Parts & Accessories Bulletin

P&A #341

P/N 65213-86

FXST Hi-Performance Exhaust System by Kerker

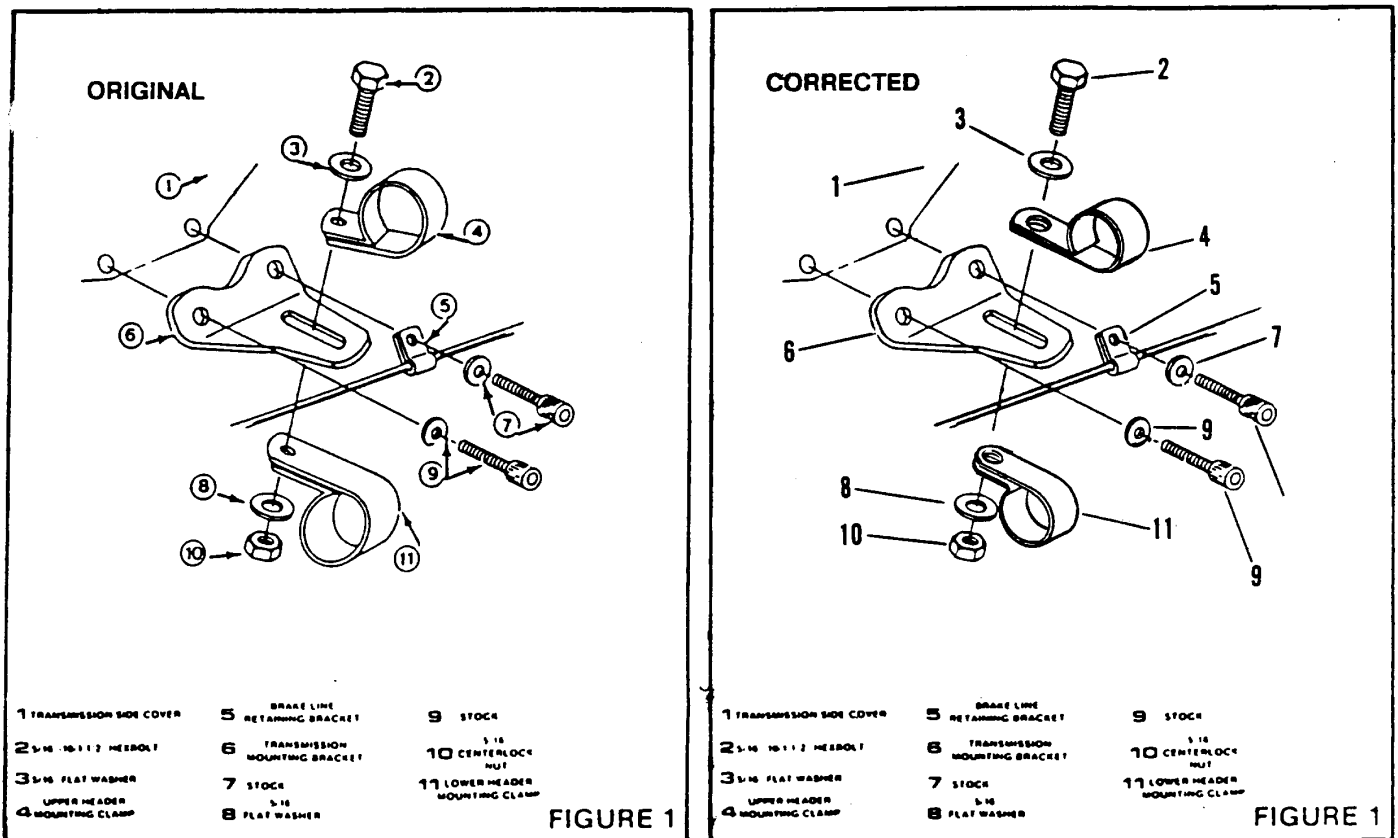
The installation procedure outlined in the Instruction Sheet supplied with the Kerker exhaust system kit part no. 65213-86 is wrong. The following is a corrected installation procedure.

See Figure 1. Figure 1 shows the original illustration and a corrected version. Item # 4 and item # 11 clamps must be interchanged, as shown in the corrected version, to properly install the exhaust system.
